**EL PASO WATER UTILITIES
PUBLIC SERVICE BOARD**

ADDENDUM NO. 2

**JOHN T. HICKERSON WRF
HEADWORKS BARSCREEN REPLACEMENT**

BID NO. 40-23

ELECTRICAL
 MCC-10B
 ONE-LINE DIAGRAM
 DEMO-SHEET

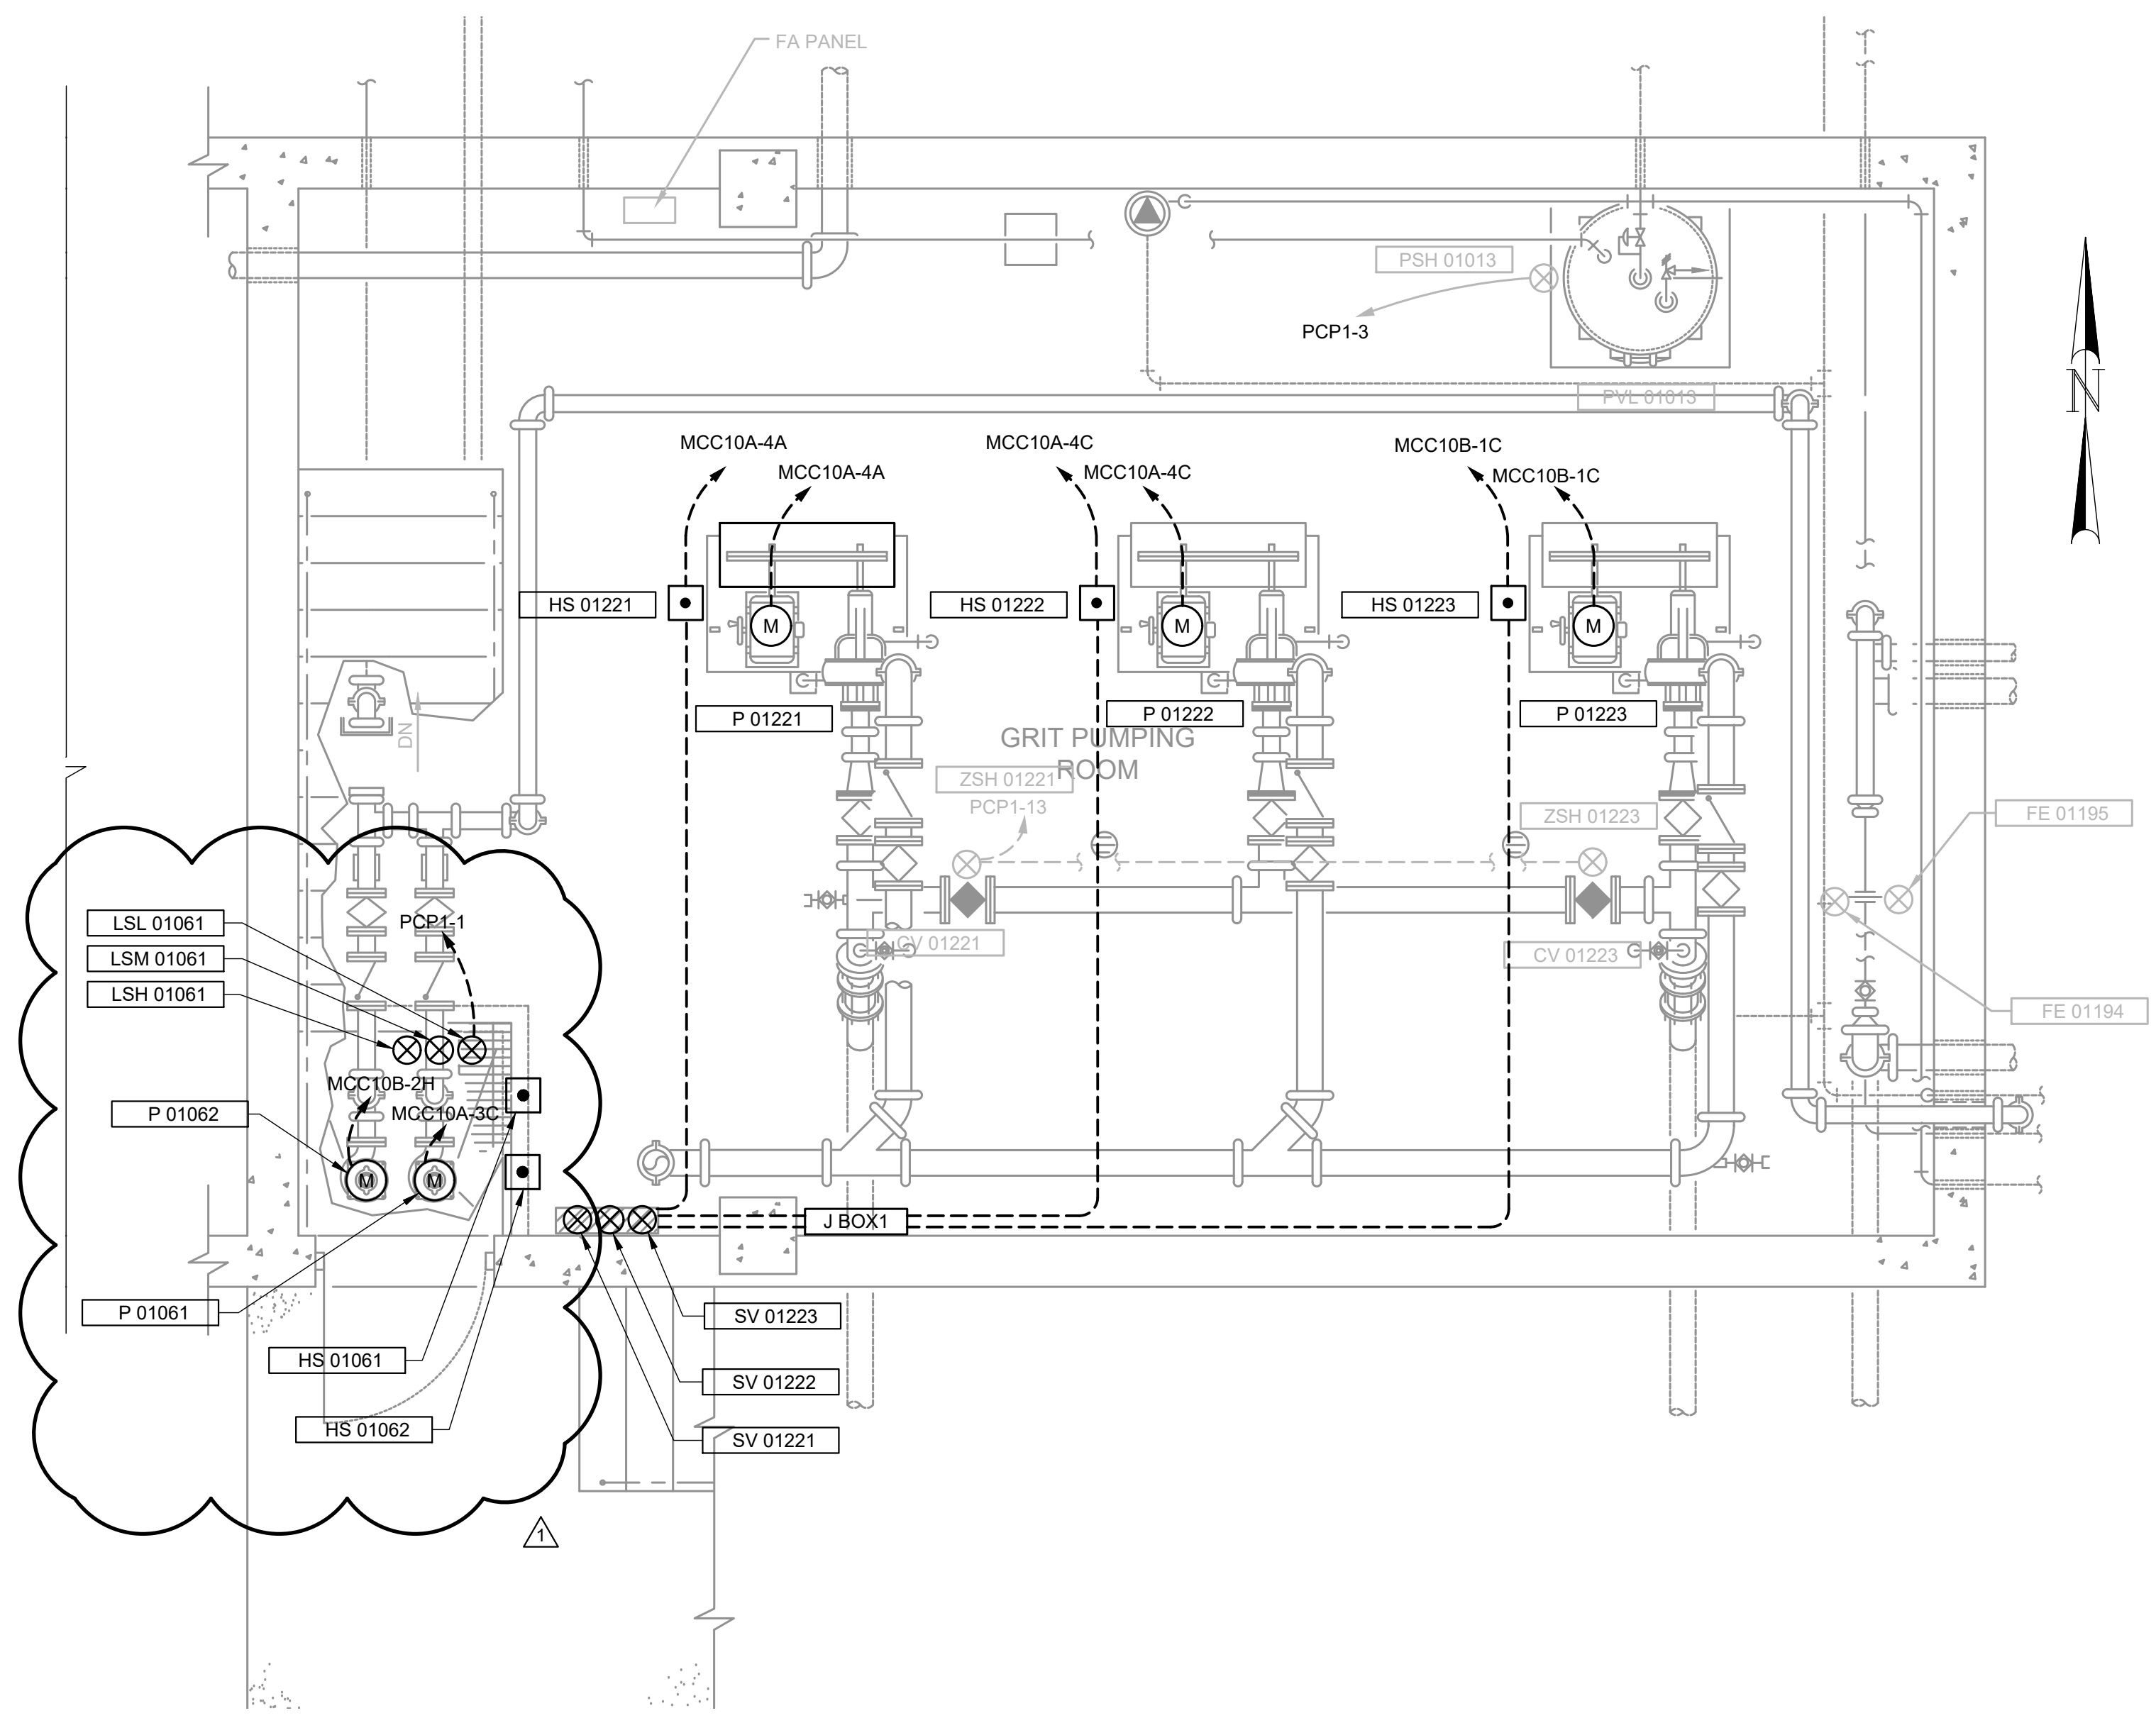
- AD-2.28. SHEET E006 - ELECTRICAL MCC-10B ONE-LINE DIAGRAM DEMO-SHEET
- A. REMOVE Sheet E006 in its entirety and REPLACE with revised Sheet E006 attached to this Addendum. Changes reflect demolition of Grit Room sump pump.

**ELECTRICAL
GRIT PUMPING ROOM
POWER PLAN**

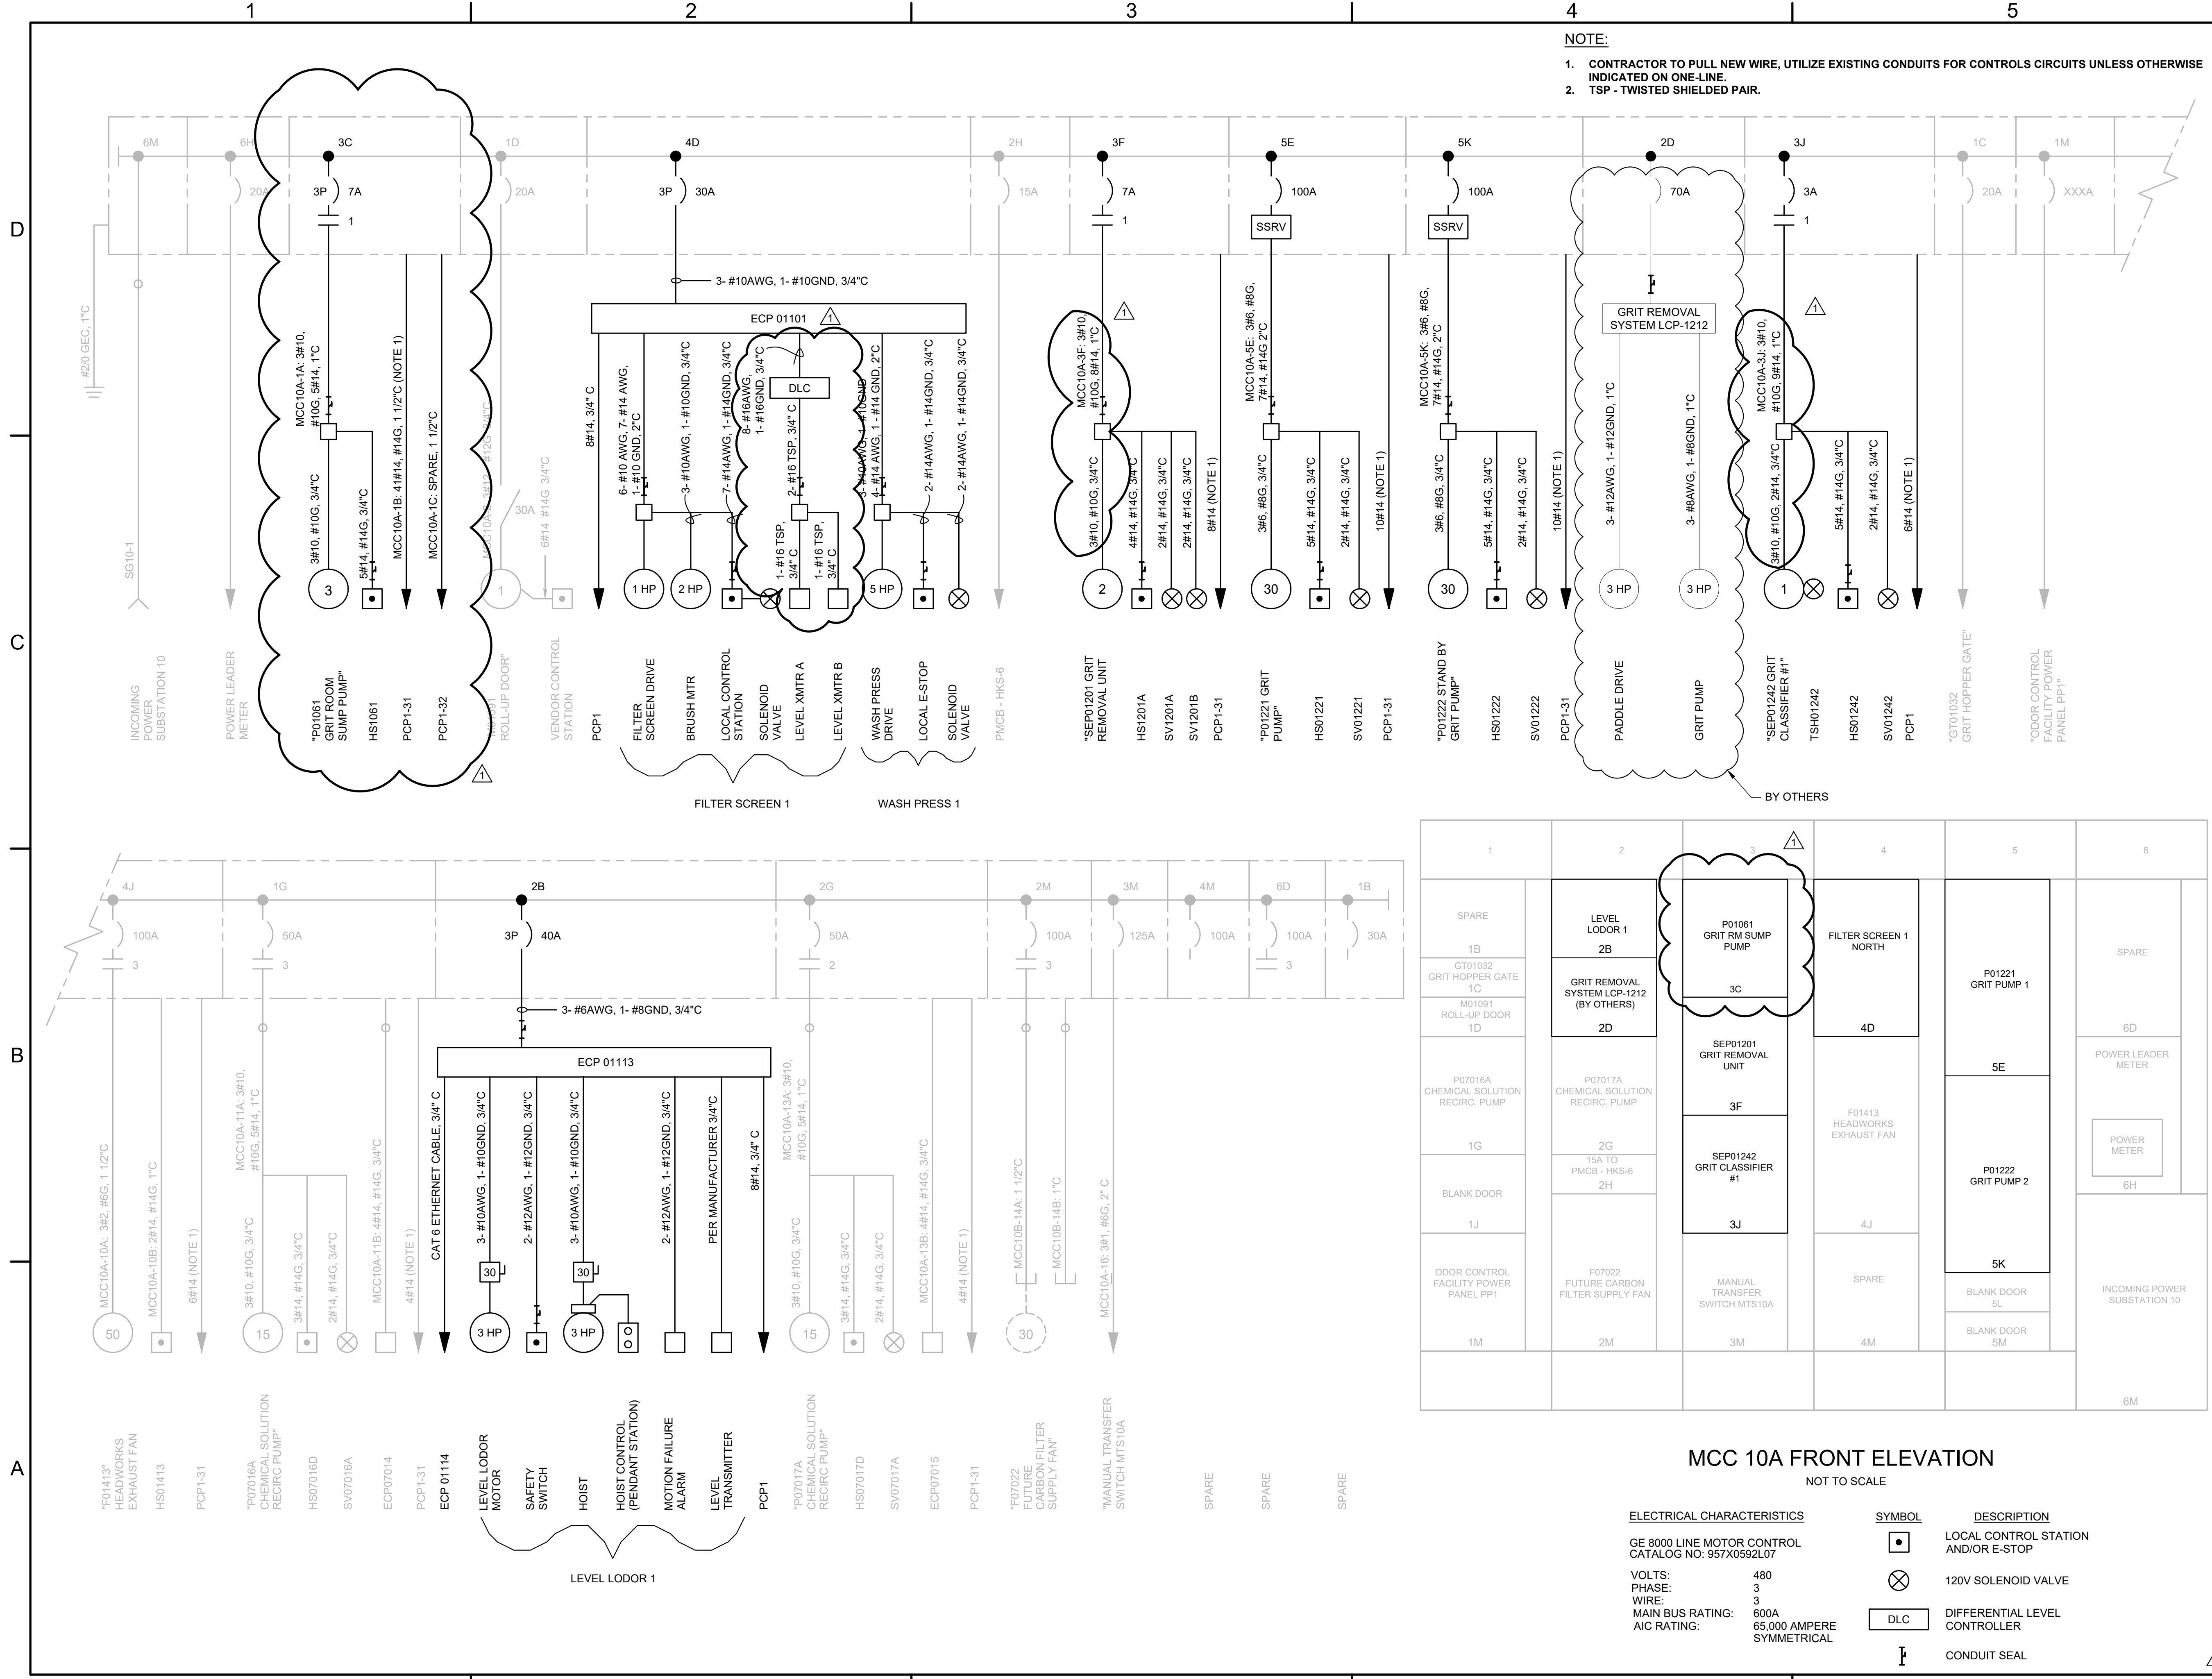
- AD-2.30. SHEET E009 - ELECTRICAL GRIT PUMPING ROOM POWER PLAN
- A. REMOVE Sheet E009 in its entirety and REPLACE with revised Sheet E009 attached to this Addendum. Changes reflect the installation of Grit Room sump pumps.

Q-2.04. Sheet M106, Plan E – Grit Pumping Room Partial plan indicates the existing sump pumps are to be removed and replaced. Sheet E004, Plan C – Grit Pump Demo Plan does not show demolition of the sump pumps. Sheet E009 does not show electrical work being required for the sump pumps. Is electrical work required?

A-2.04 Electrical work will be required. See Addendum Drawings for electrical demo and replacement work related to replacement of Grit Pumping Room sump pumps.
